Response to Reviewers

Manuscript title: Surrogate-conditioned optimizer ranking in block-scale urban energy design: A comparison of policy learning and Pareto search

Manuscript ID: APEN-D-26-08148

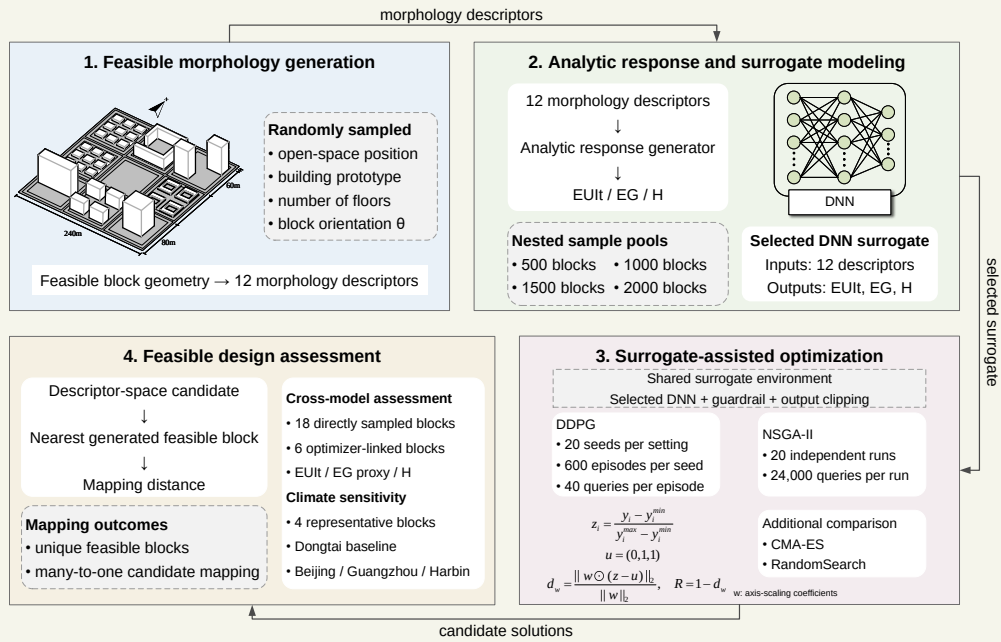
Figure 1: The caption should be improved to explain the content of the figure in more detail.

We thank the reviewer for this helpful suggestion. We agree that the original Fig. 1 caption was too brief for a workflow figure that introduces the full methodology. In the revised manuscript, Fig. 1 is used to orient the reader before the detailed method sections, so the caption now explains the main computational stages rather than only naming the figure.

We revised both the paragraph before Fig. 1 and the figure caption. The paragraph now explains that the study distinguishes generated feasible block geometries, morphology descriptors used by the surrogate and optimizers, and locked block cases used in selected physics-based and climate-sensitive calculations. The caption then describes the workflow in order: feasible morphology generation, analytic response and surrogate modelling, surrogate-assisted optimization, and feasible design assessment.

This revision also prevents a possible misunderstanding in the original manuscript. The figure and caption now make clear that the 2000-sample benchmark uses analytic response assignment, whereas EnergyPlus- and Radiance-component calculations are used later for selected locked cases in the cross-model stress test and climate sensitivity analysis.

We made this distinction in the caption itself because readers often use Fig. 1 as the entry point to the method. The revised caption therefore carries the workflow boundary before readers reach the more detailed equations and result sections.

Revised Fig. 3. DDPG actor-critic architecture and target-network update structure used in the surrogate-query environment. The

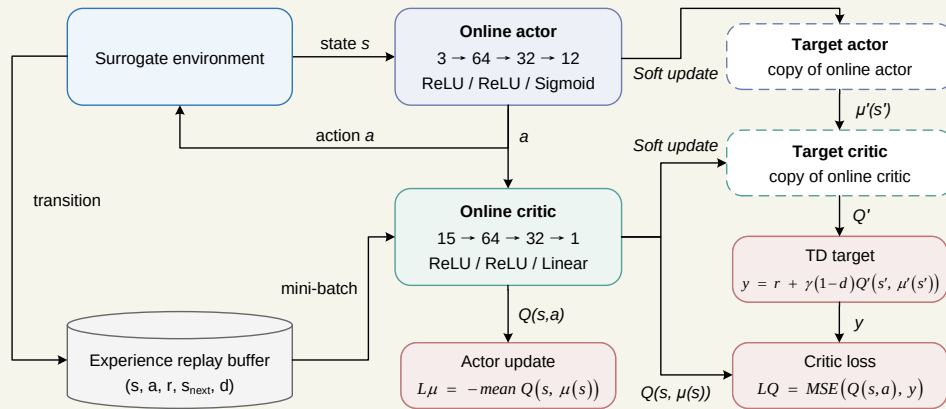
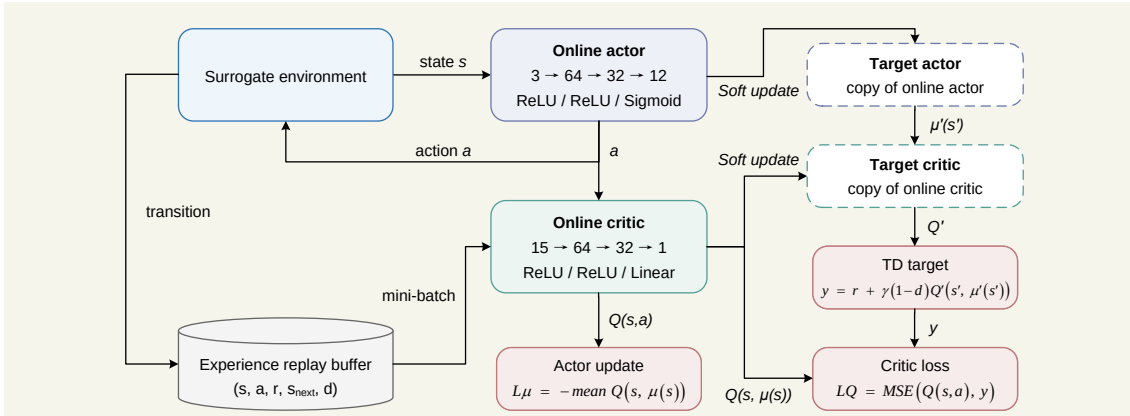
Figure 3: The manuscript does not include the explanation of the Figure 3. Moreover, the authors need to explain the symbols and equations in the Figure 3.

We thank the reviewer for this comment. We agree that the previous manuscript did not explain Fig. 3 sufficiently. The figure contained the actor-critic architecture and update equations, but the surrounding text did not define the state, action, reward, target networks, temporal-difference target, critic loss, and actor update in enough detail.

We revised Section 2.4 and the Fig. 3 caption. The revised text now defines the DDPG state as the normalized three-target vector, the action as the absolute 12-dimensional normalized descriptor query, and the reward as $R = 1 - d_w$. It also explains the online actor, online critic, target actor, target critic, replay buffer, TD target, critic loss, actor update, and soft target-network update shown in Fig. 3.

We also added the reward equations directly in the manuscript. The equations define the normalized target coordinate z_i , the ideal vector $\mathbf{u} = [0, 1, 1]^T$, the weighted normalized distance d_w , and the reward $R = 1 - d_w$. This removes the previous reward-offset wording and makes the symbols in Fig. 3 consistent with the method text.

The revision also connects the equations to the diagram. Readers can now follow one DDPG update from a descriptor action, through guarded surrogate prediction, to the reward and TD target used by the critic. This makes Fig. 3 an explanation of the actual surrogate-query implementation rather than a generic actor-critic schematic.

We made three corresponding revisions. First, we expanded Section 2.4 to define the DDPG components. Second, we redrew Fig. 3 as a static surrogate-query architecture diagram. Third, we added the corrected normalization and reward equations.

Revised Fig. 4. Descriptor coverage and cross-validated surrogate predictions.

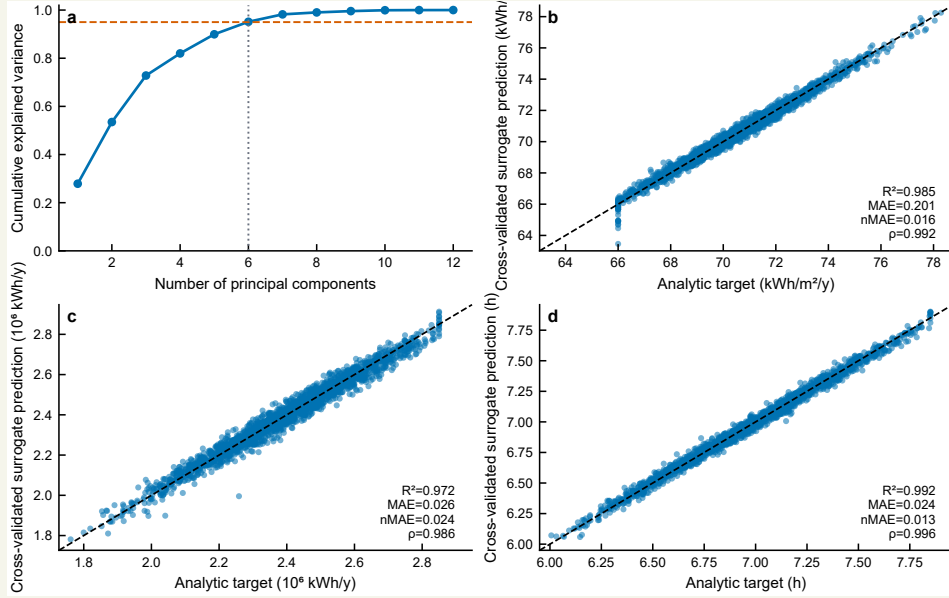
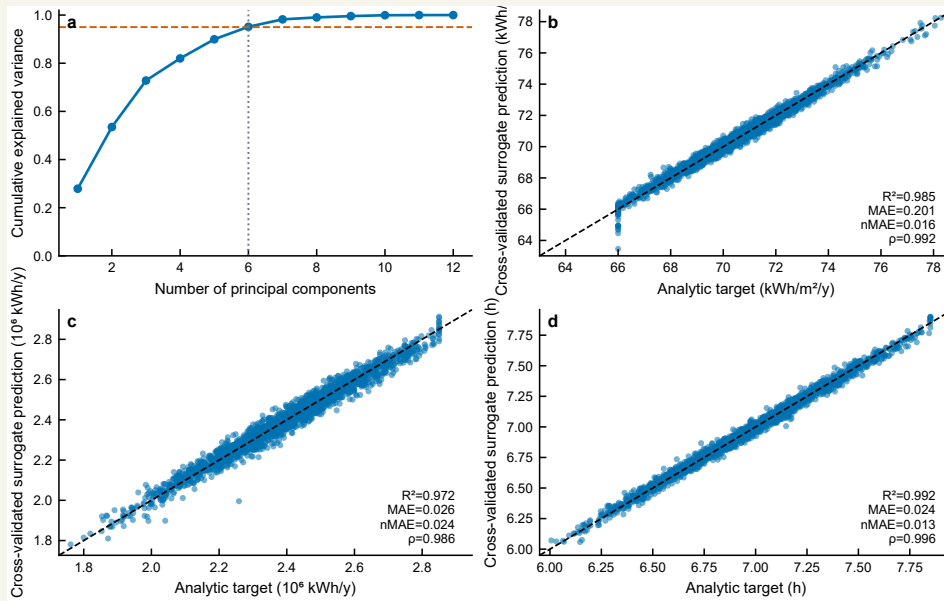
Figure 4: For parity plots, the ticks and limits of the x- and y-axes should be same. All plots should be rescaled. Please specify unit in each axis.

We revised Figs. 4, 5, and 9, Tables 1, 3, and 6, and Supplementary captions and tables to standardize target units, morphology units, one-to-one reference lines, and figure captions.

The revised figures and tables label EUIt in $\text{kWh m}^{-2} \text{y}^{-1}$, EG in 10^6kWh y^{-1} where that scale is used, H in hours, and morphology quantities by their unit or type. This correction changes presentation only; the underlying numerical results are unchanged.

Revised Fig. 6. DDPG training trajectories across the three preference scenarios.

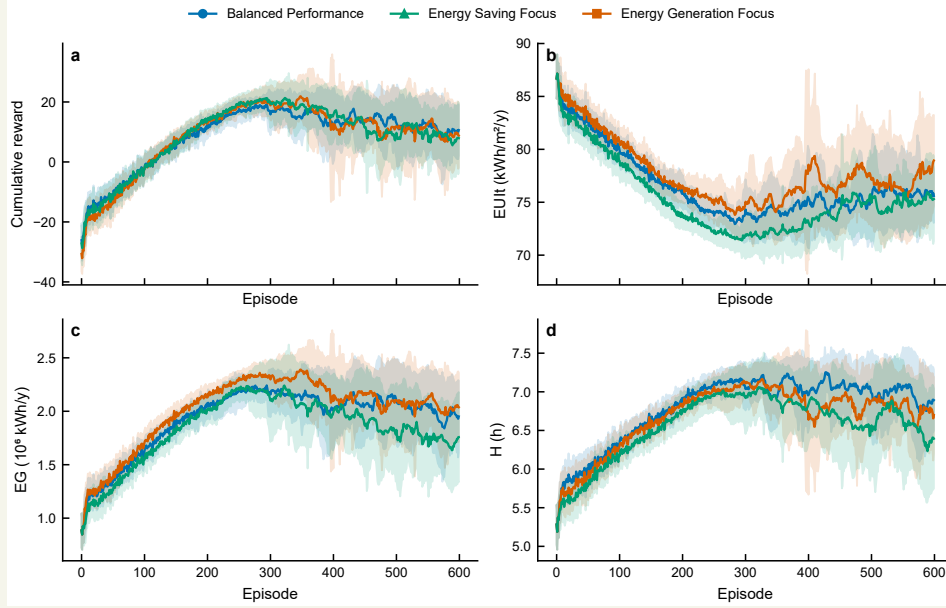
Figure 6: Please explain what the episode means in the plots.

We revised Sections 2.4 and 3.2, Figs. 2 and 6, and Supplementary Section S3.1 to define one episode as 40 surrogate-query steps and align the training-curve captions with that definition.

We made three corresponding revisions. First, we rewrote the episode definition in Section 2.4. Second, we revised Fig. 2 and Fig. 6 captions around surrogate-query steps. Third, we added supporting detail on seed-level DDPG behaviour in Supplementary Section S3.1.

Figure 6 describes how the DDPG agents interact with the guarded surrogate during training. Across the three preference scenarios, rewards increase rapidly during early training and then enter a high-reward region with visible seed-to-seed variability. Because each episode contains a fixed sequence of 40 surrogate queries, the trajectories represent policy-training behaviour on a static response surface. They should therefore be read as search trajectories over descriptor queries, not as the physical evolution of one block design.

Revised Fig. 2. Serialized DDPG surrogate-query workflow. Each episode contains 40 absolute descriptor queries.

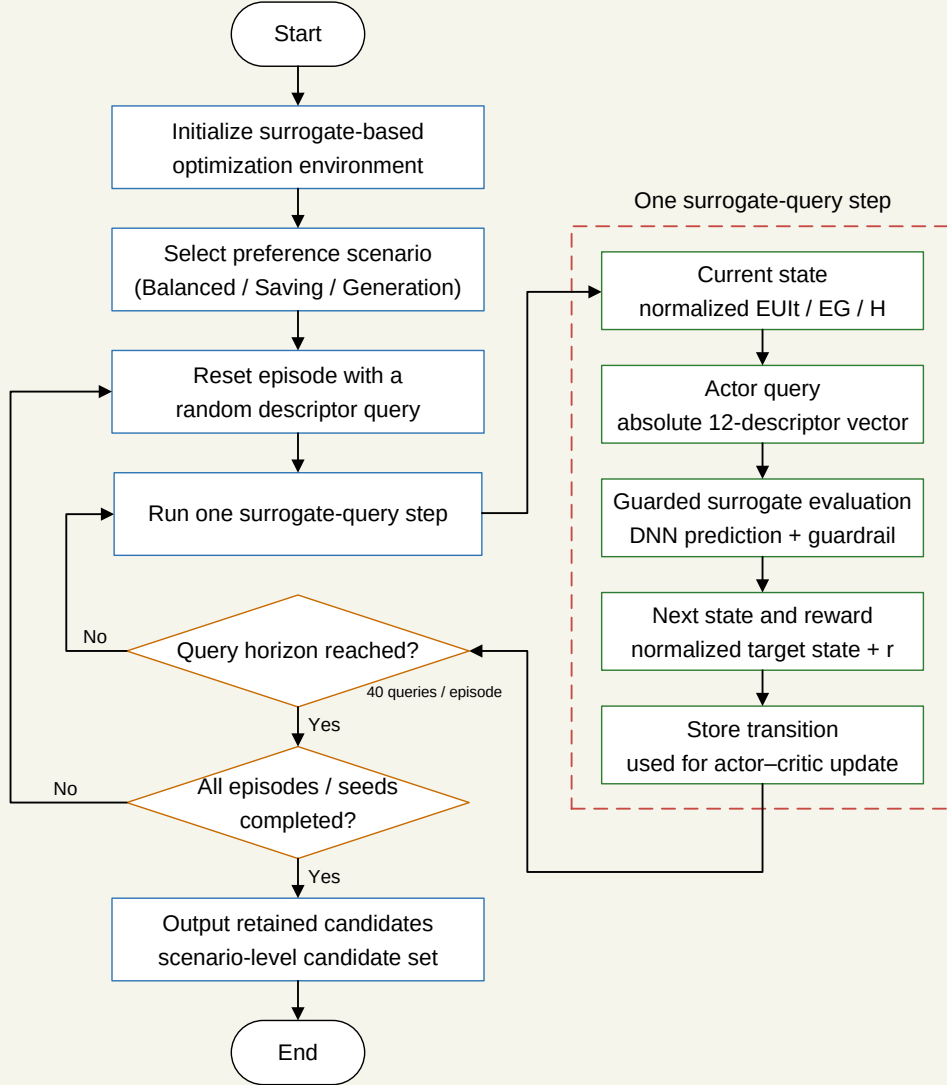
The RL formulation remains questionable because the problem is essentially a static black-box optimization problem rather than a naturally sequential decision-making process. The state transition is determined by the surrogate response to a morphology vector, and the sequential meaning of episodes and steps is unclear.

We made four corresponding revisions. First, we rewrote Section 2.4 around the static surrogate-query environment. Second, we revised Figs. 2 and 3 to explain the serialized query workflow and actor-critic update. Third, we corrected the reward equations. Fourth, we revised Section 3.2 and Supplementary Section S3.1 to clarify that episodes describe training behaviour on a static response surface.

Revised Fig. 1. Workflow linking feasible morphology generation, analytic response assignment, surrogate-assisted optimization, feasible-block projection, and sensitivity analysis.

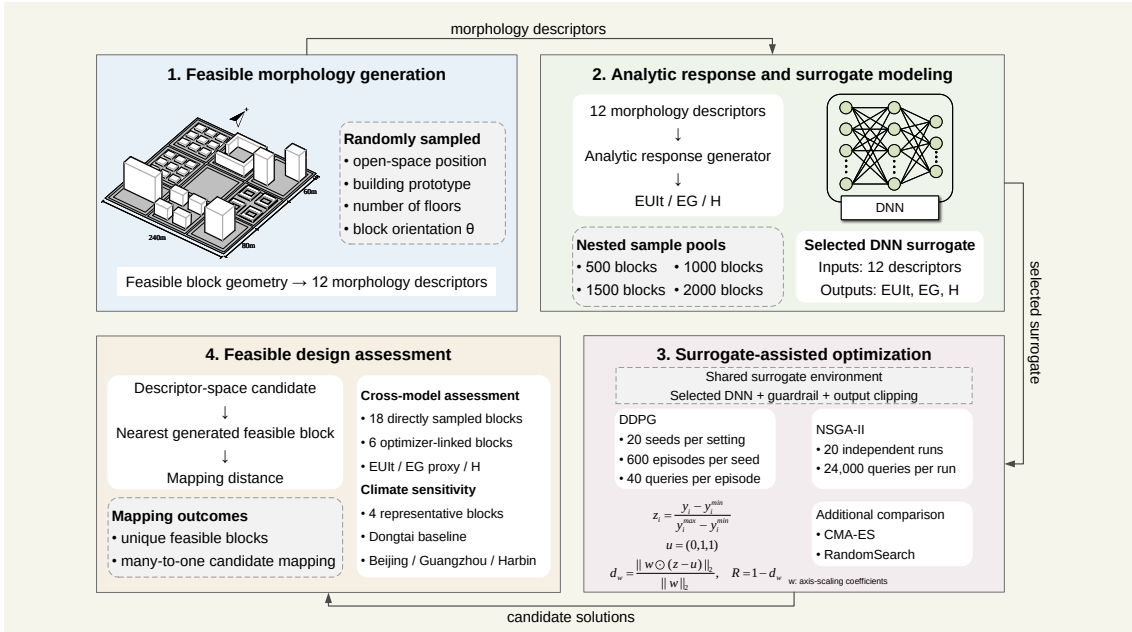
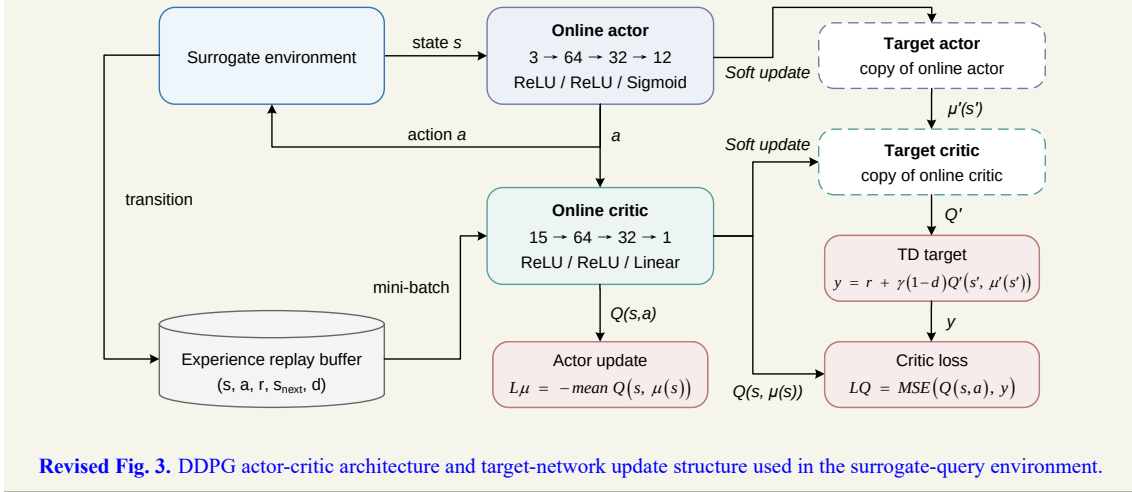
Correct spelling and wording errors in the workflow figures. For example, Fig. 1 still contains visible typos such as "loactions," "Acotr network," and "Critic network," which should be revised to "locations," "Actor network," and "Critic network."

We revised Fig. 1, Fig. 3, and their captions to correct the typo and align figure labels with the revised methodology and DDPG terminology.

Fig. 1 now uses consistent workflow-module labels, while Fig. 3 uses standardized labels for actor, critic, replay buffer, target networks, state, action, and reward path. This is a presentation correction and does not change the method or results.

We made two corresponding revisions. First, we corrected the typo and terminology issues in Fig. 1 and its caption. Second, we corrected Fig. 3 and its caption so that the DDPG labels match the revised method description.

Revised Fig. 7. Descriptor-space DDPG and NSGA-II comparison under fixed-domain utility and equal-size retained outputs.

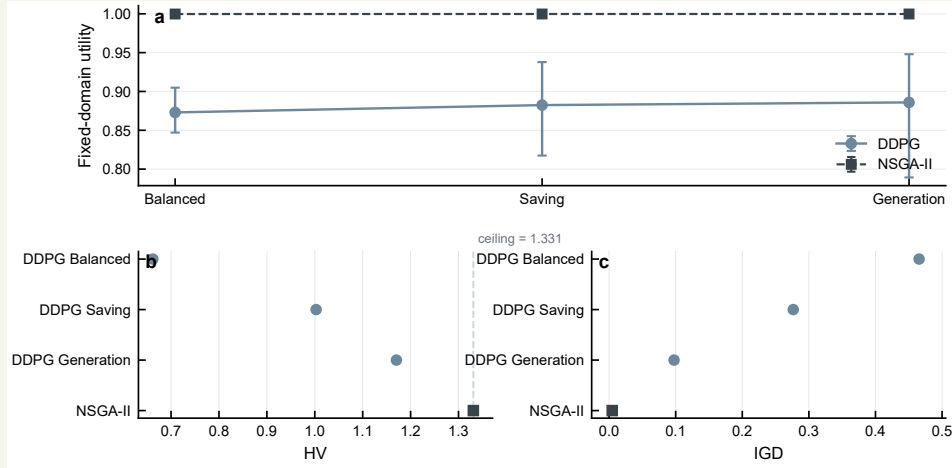
Verify the consistency between Fig. 9(d) and the stated benchmark conclusion. The text states that NSGA-II remains stronger than all DDPG scenarios, but the utility panel should be carefully checked to ensure that the plotted curves, legend, and utility direction support this conclusion.

We revised Sections 3.3 and 3.4, Table 5, Figs. 7 and 8, and Supplementary Sections S3 and S5 to rewrite the comparison around fixed-reference descriptor-space metrics, equal-size diagnostics, and projection.

We made three corresponding revisions. First, we rewrote Sections 3.3 and 3.4 to separate scalarized candidate selection, descriptor-space HV and IGD, equal-size diagnostics, and feasible projection. Second, we revised Table 5 and Figs. 7–8 around those criteria. Third, we removed the previous utility-only interpretation from the main claim.

Table 5 summarizes descriptor-space performance under the fixed normalized reference front, while Fig. 7 separates fixed-domain utility from equal-size archive metrics. NSGA-II is close to the HV ceiling under the fixed reference and remains the strongest method in the equal-size HV and IGD comparison. Among the three DDPG settings, the Generation-focused scenario gives the strongest descriptor-space archive metrics, followed by the Energy Saving and Balanced settings.
